THE HOTEL AT FOUNDRY PLACE, "LOT 3": 165 DEER STREET, ASSESSORS MAP 125 LOT 17, AND RELATED IMPROVEMENTS TO LOTS 2, 4 AND 5

SITE PLAN REVIEW

COVER SHEET

CONSTRUCTION AND MAINTENANCE EASEMENT

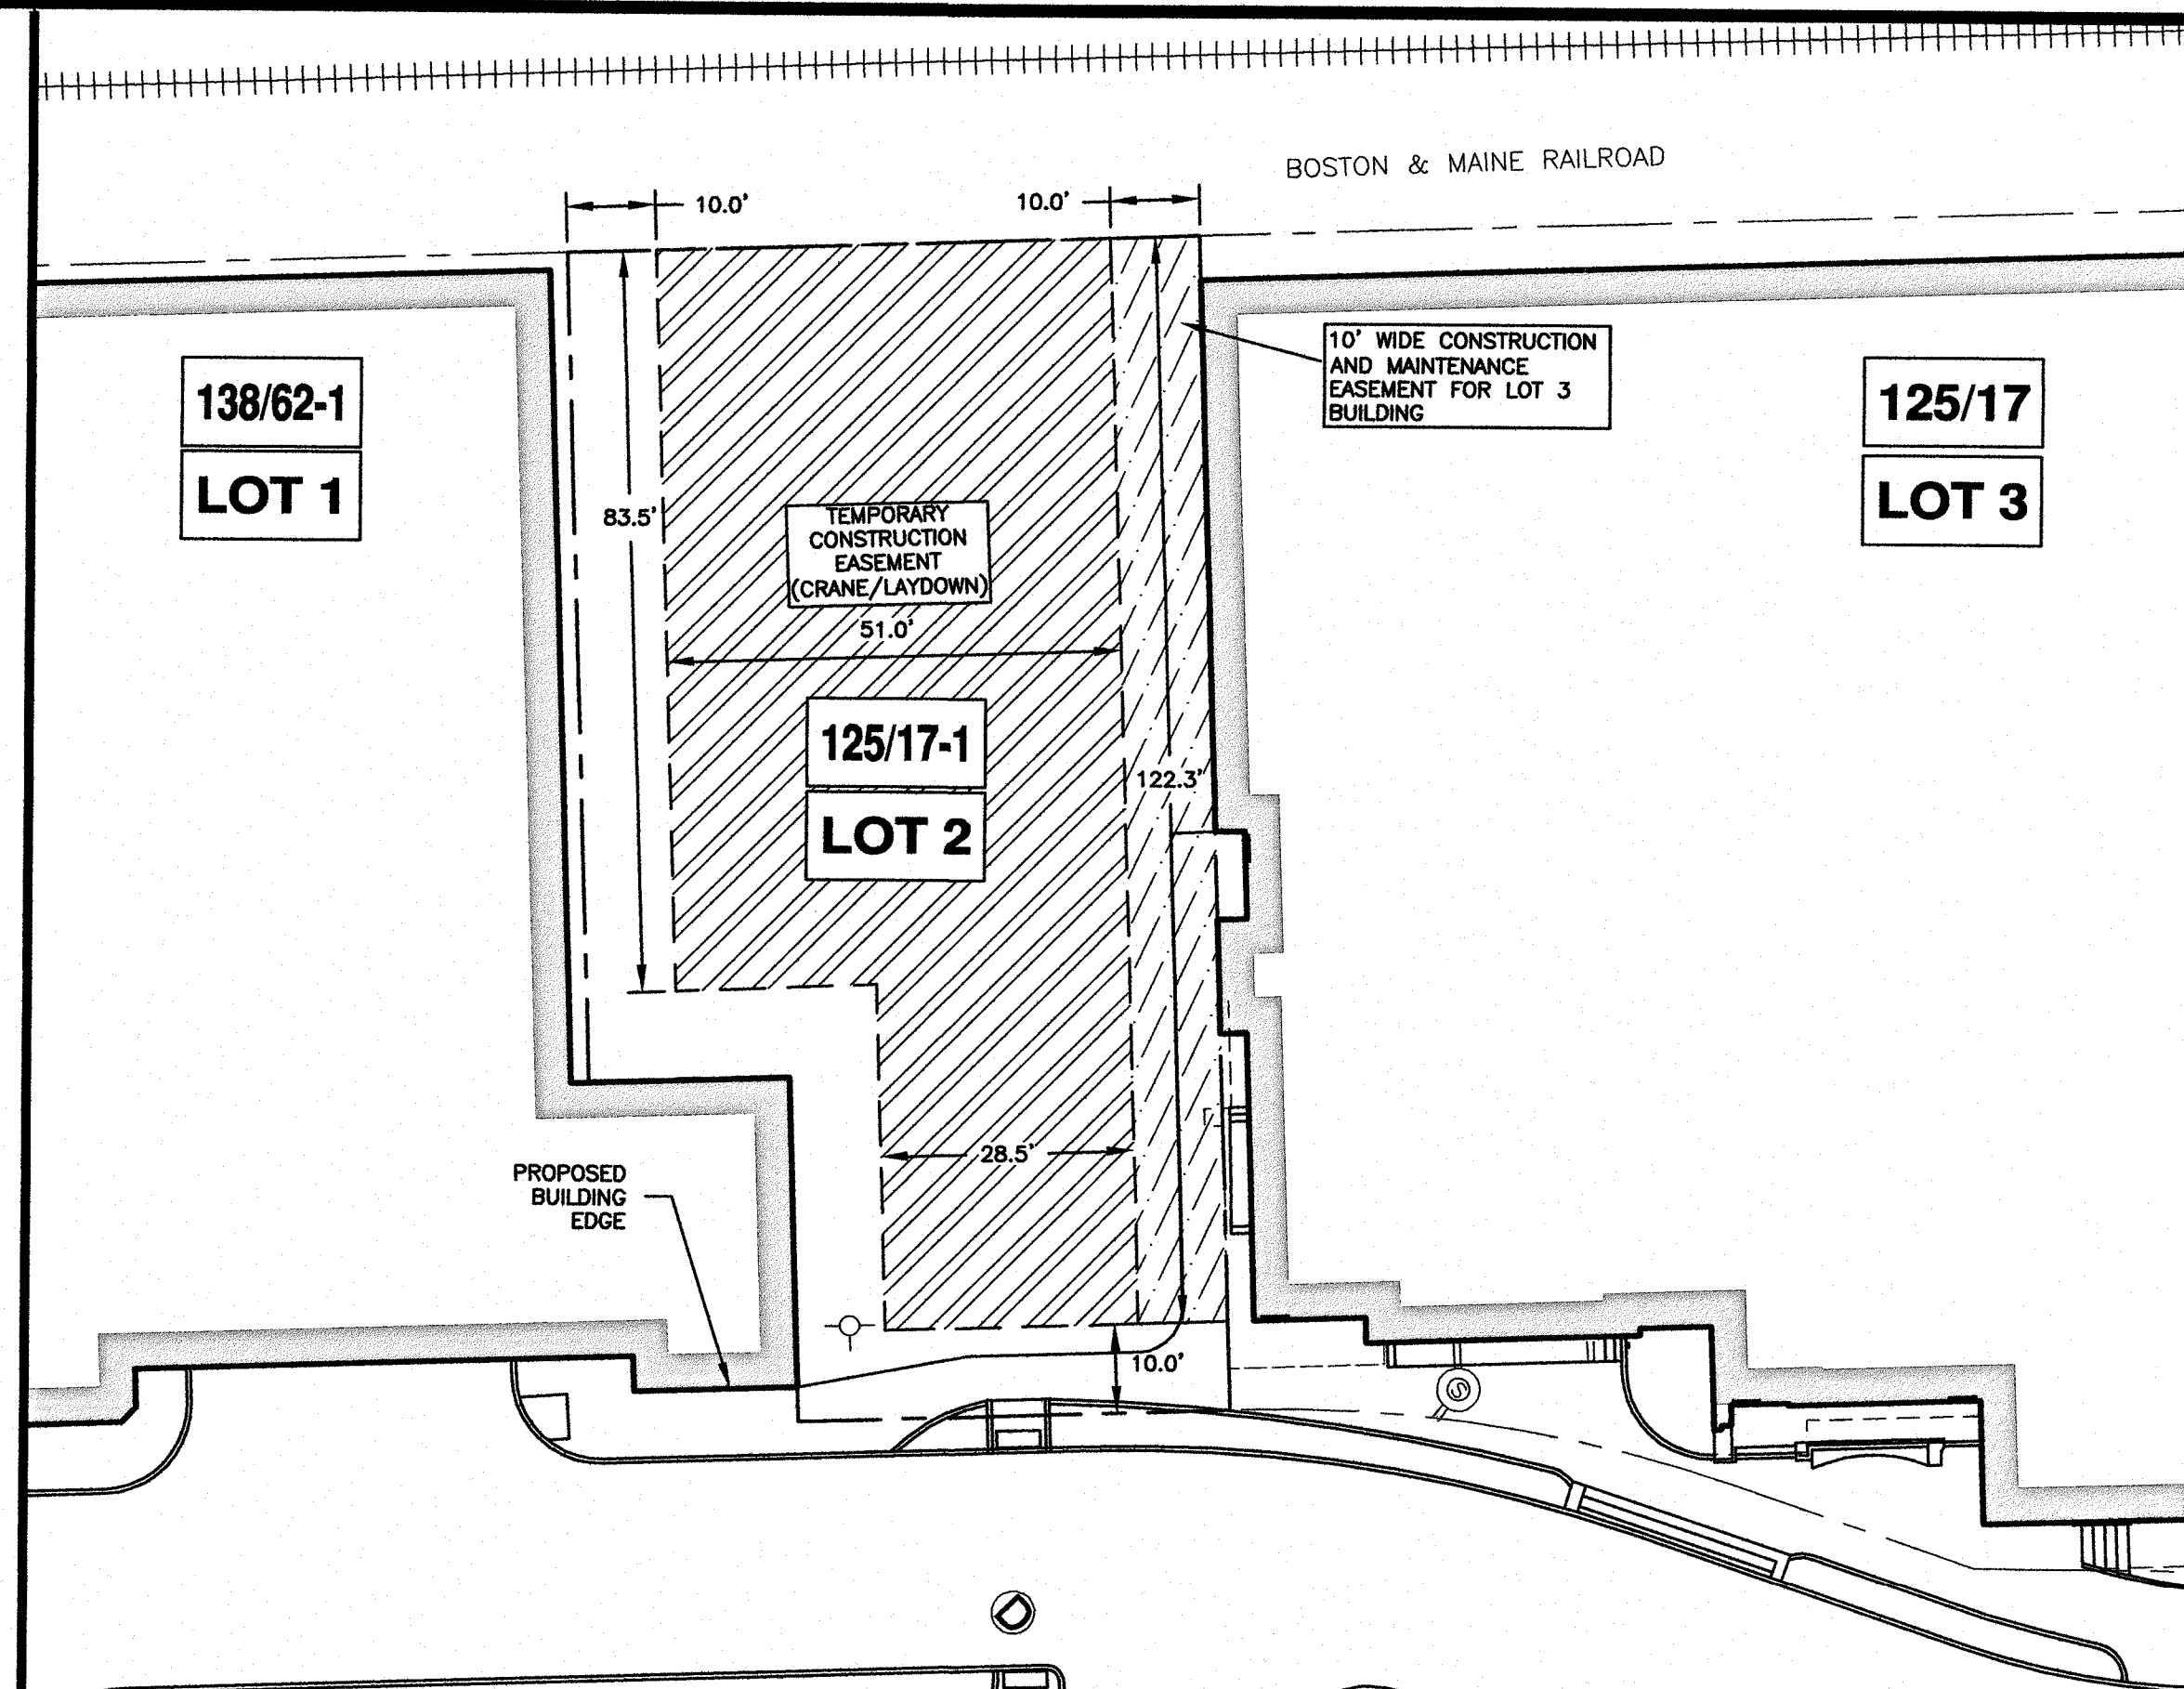
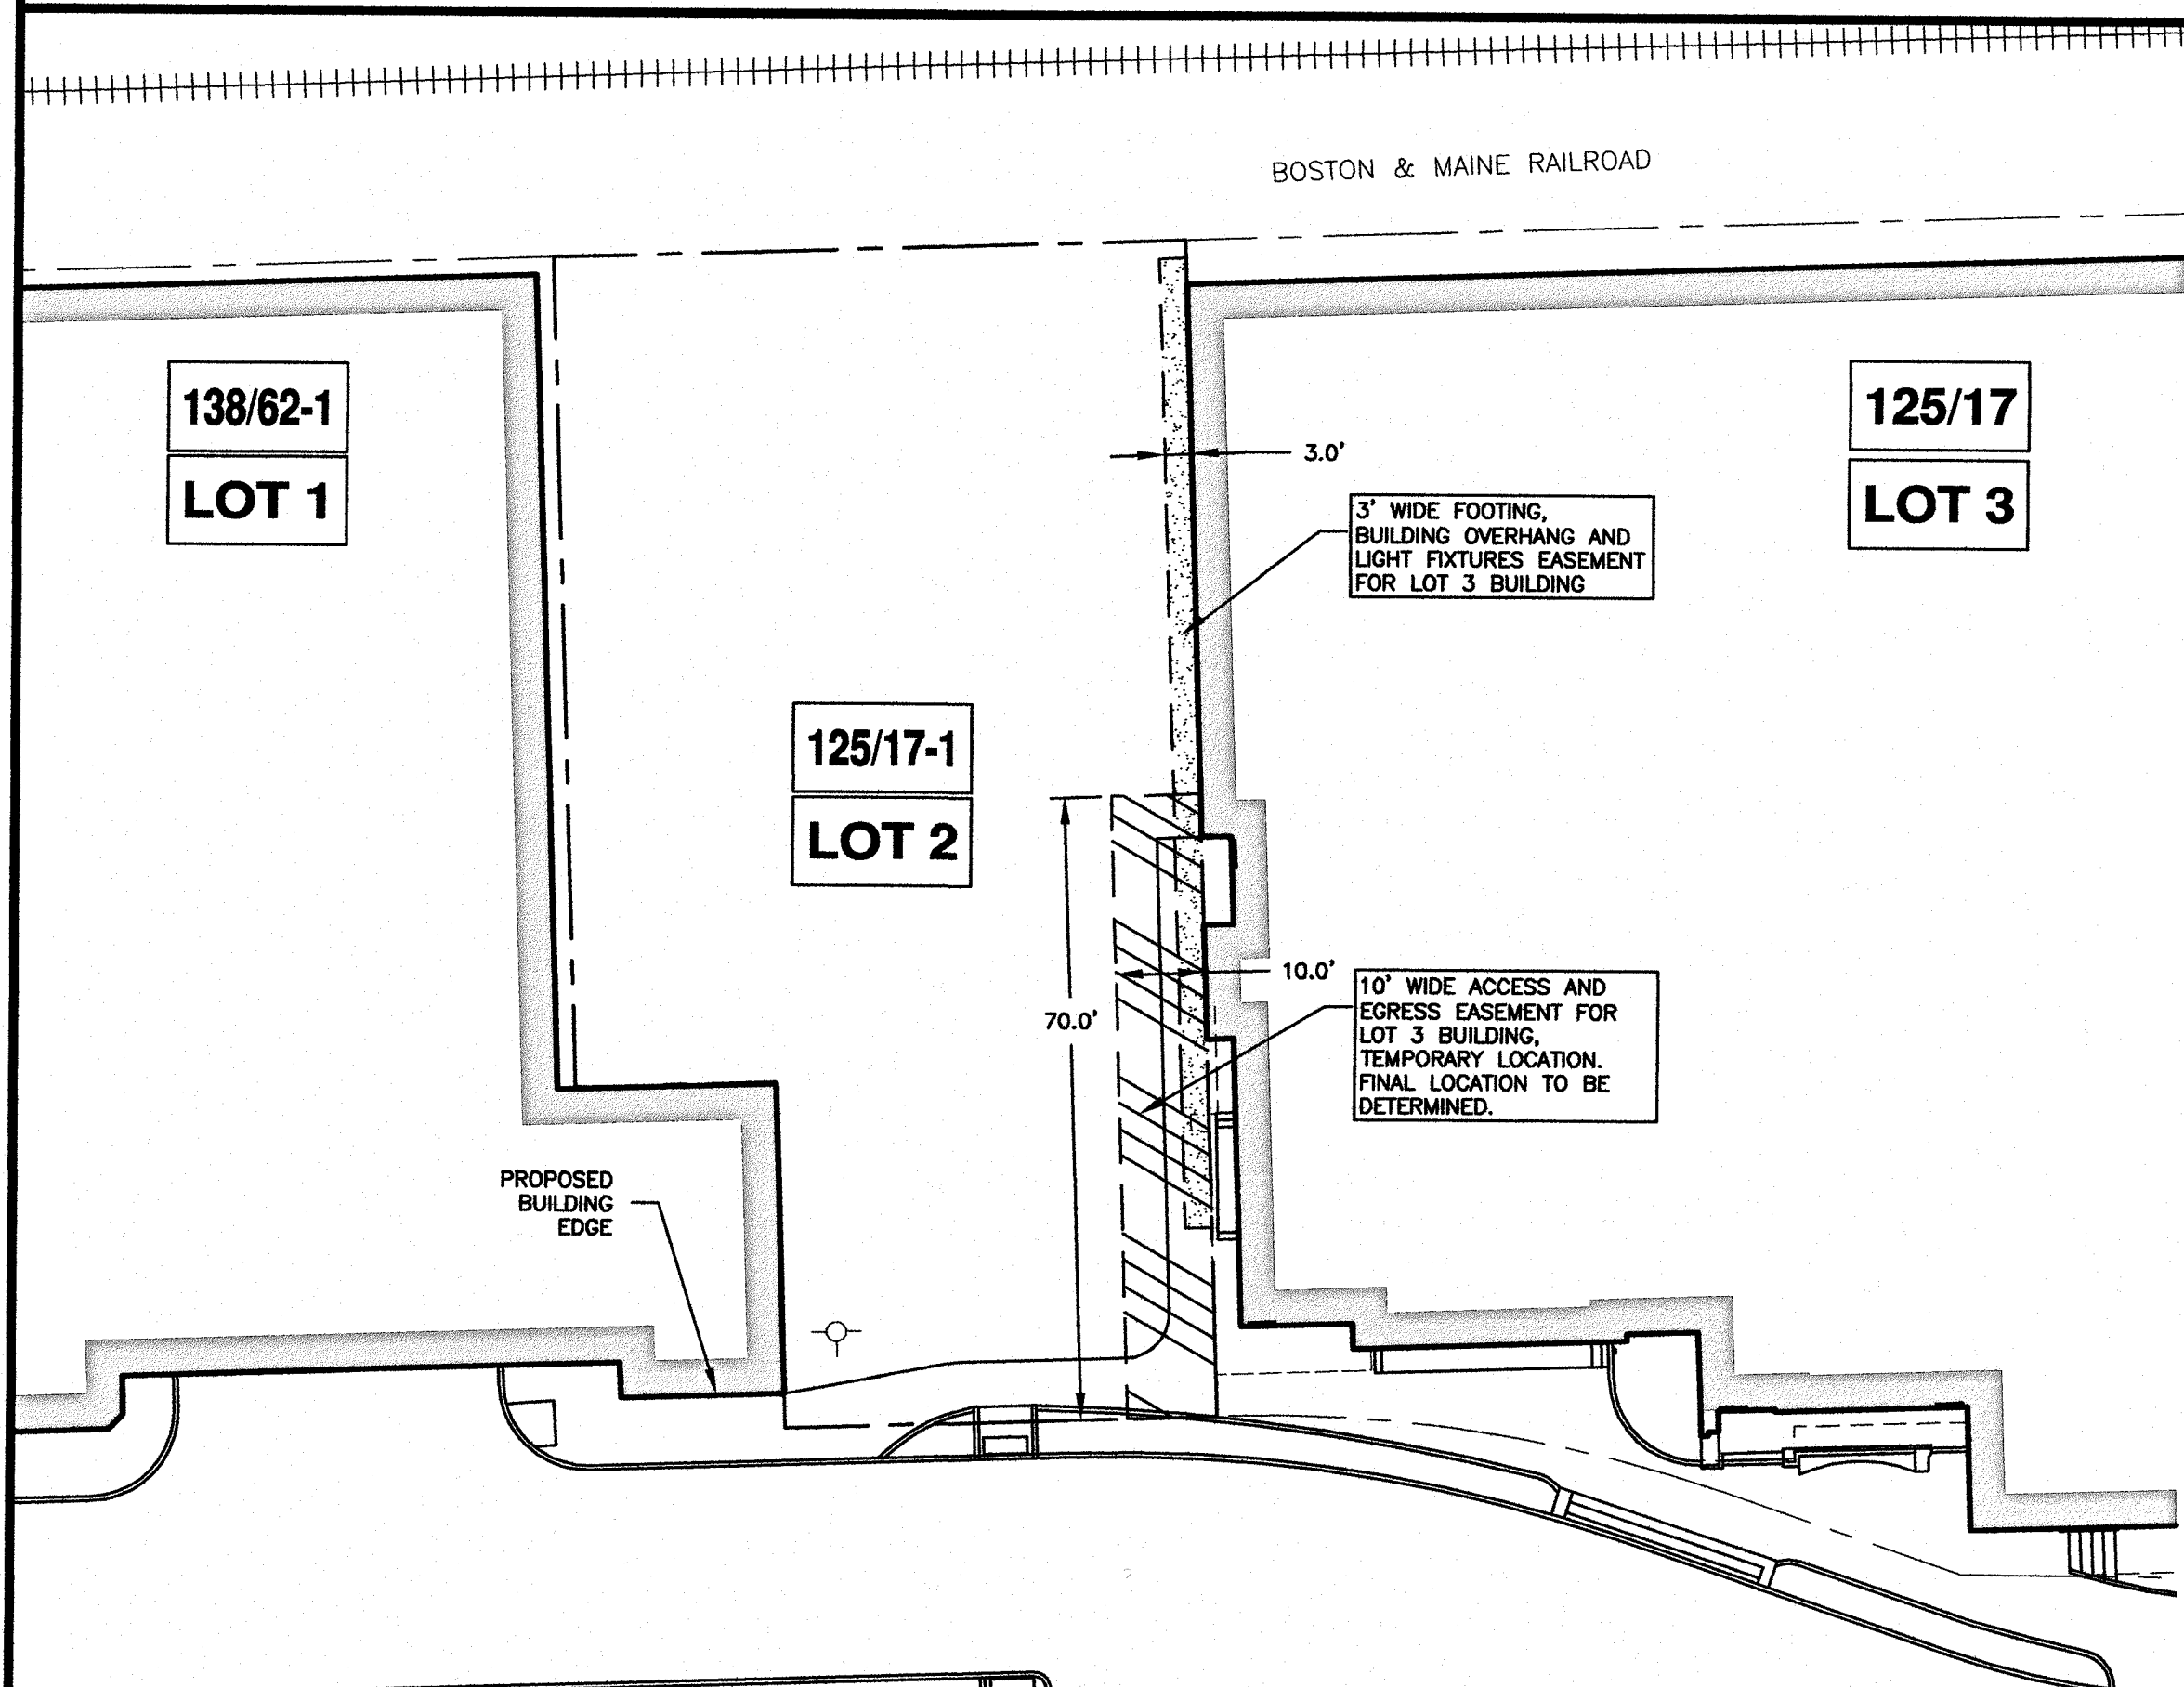
22	Update the Easement Table and Easement Figures to match; make sure it includes the electric easement on Lot 4 for Lot 3.	Resolved	Sheets E1, E2, and E3, and the Easement Summary Tables included in Attachment B were edited to be consistent and are included in the submittal.
23	City wants to control the ability to light the sidewalk, therefore they want decorative City street lights installed. Resolve light provided/guaranteed by building with City lights.	Addressed	Sidewalk lights are shown on Sheet L2. Updated building lighting information is included in Attachment G.
24	Update the zoning compliance table to include required dimensional information. Update square footage.	Addressed	Zoning compliance table updated. Dates of approvals for variances sought also included (Sheet T.02T).
25	Revisit Community Space calculation if outside tables are going to be used on sidewalks.	Addressed	Community Space calculations and illustrations (Sheet C3.3) was revised to exclude terrace area in front of hotel and is included.
